Re: Fourth Submission Review: E. 60th Avenue at Box Elder - Infrastructure Site Plan
Application Number: DA-1478-14
Case Numbers: 2024-6039-00

Fourth Submission Review

Project Review for 60th Ave at Box Elder Development

DEN Aviation Noise:

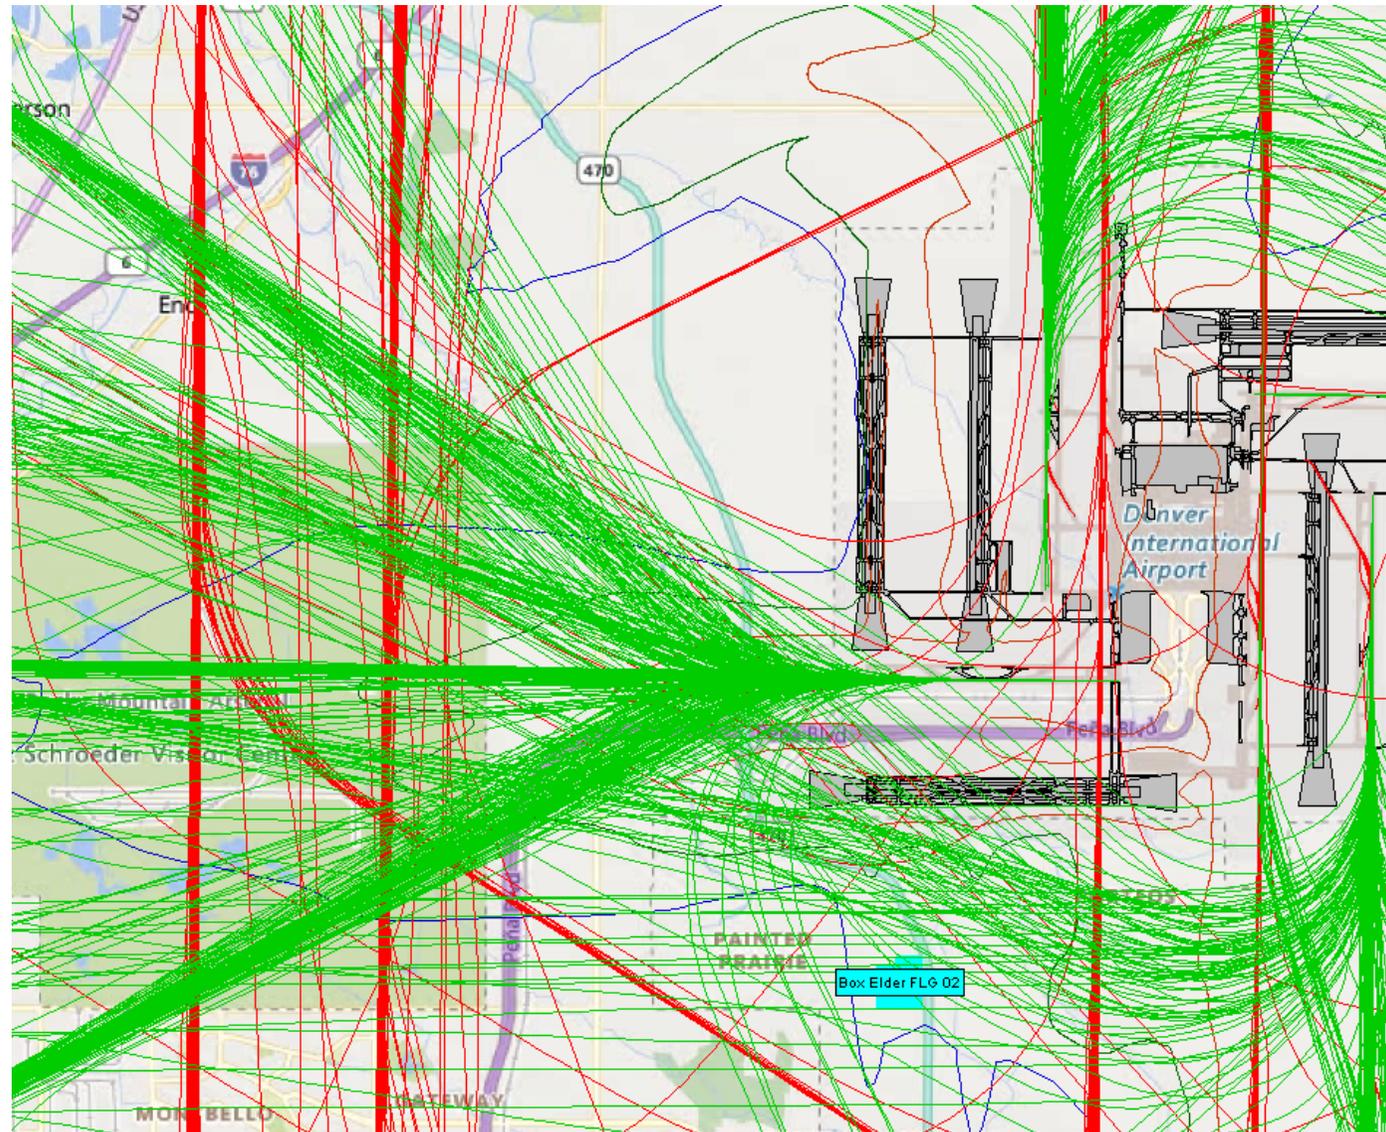
This property will be subject to overflights to and from Denver International Airport (DEN). Included are flight track maps showing the different flight track pattern scenarios and their altitudes related to the arrivals and departures at DEN. All related aviation noise statements should be included in any information sharing, documentation and contracts.

This subject property area is not currently directly under an arrival pattern, the future north/south runways on the west side of the airfield will put arrivals over the subject property. The development could potentially have arrival overflights from the south at altitudes of between 1,100 feet above ground level (AGL) and 1,500 feet AGL depending on the aircraft type and what arrival runway the Federal Aviation Administration (FAA) air traffic controllers have directed the aircraft to land on. If the winds are out of the north aircraft will land coming in from the south on final approach to DEN. Aircraft currently arrive to DEN on runways 34L and 34R and with the potential of 4 North/South runways on the West side of the airfield there could be even more daily arrival overflights of this development. The future runways are depicted in **black and gray** on this map of flight data from 5/4/23. This days of flights depicts a typical flight pattern for a 24 period. See next page for a zoomed in version.
